DEPARTMENT OF NATURAL RESOURCES
DIVISION OF OIL, GAS AND MINING

RE: Technical Field Visit to the #1 Mine Site, Plateau Mining Corporation, Star Point Mine, C/007/006

TECHNICAL MEMO

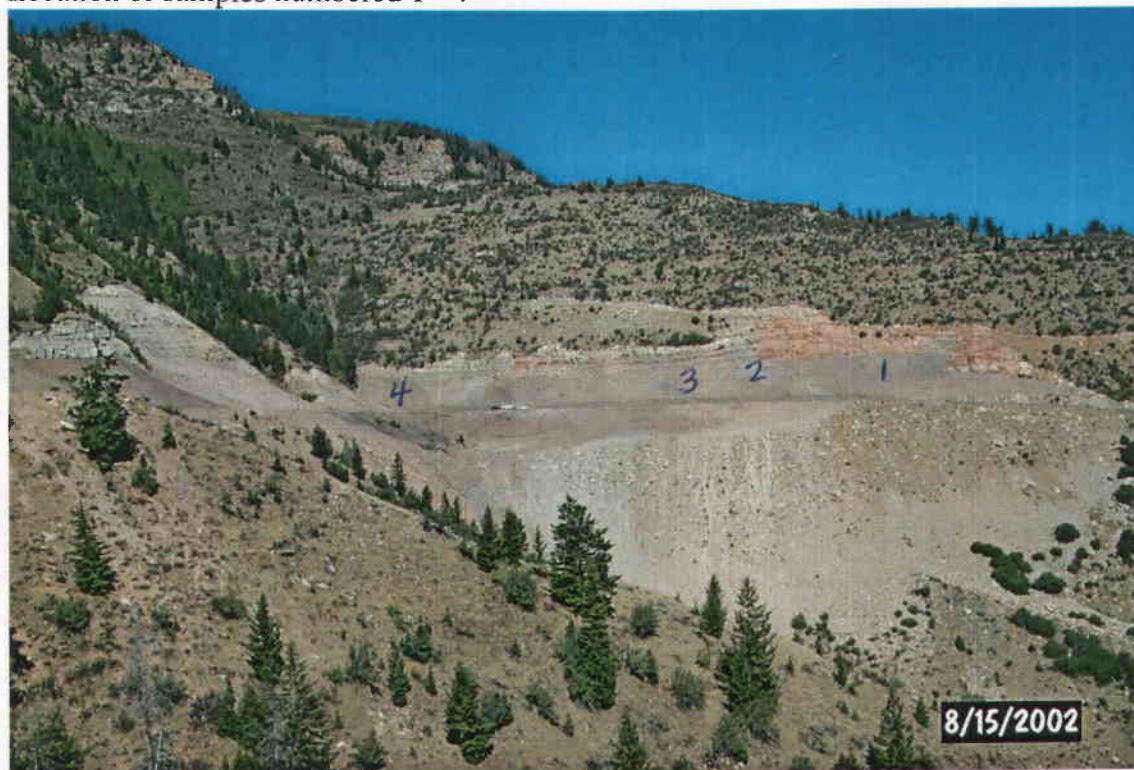
Pyramat, a woven plastic mat, was being installed in a drainage with a grade varying from 33-50%. Other drainages with grades up to 100% will also have Pyramat installed. The Pyramat was laid in the drainage, anchored to the soil with steel pins, and secured on the edges with soil. According to the manufacturer's installation instructions, the exposed surface of the Pyramat has approximately one inch of soil covering. This will allow vegetation to germinate and send roots down through the Pyramat. A registered P.E. was on-site to ensure that the drainages were constructed properly and that the Pyramat was installed according to plan.

Work had started on the lowest, main drainage. The drainage is 3400 feet long with an elevation drop of 250 feet from top to bottom. Several smaller drainages will connect directly into the main drainage. The drainage that flows down from an old catch-pond was being constructed. Concrete from the coal stacking tube and reclaim tunnel installations will be buried in the main drainage. Some pieces were already buried in the slopes where soil was being placed, and rebar was sticking up from under the soil. If this is still a problem once the full depth of soil is placed, the rebar will be cut and the soil repositioned.

Construction of the drainages is proceeding as planned and should continue to do so. Photos from this field visit may be viewed on the Internet at:
<ftp://dogm.nr.state.ut.us/PUB/MINES/Coal/C007/006/IMAGES/08152002/>
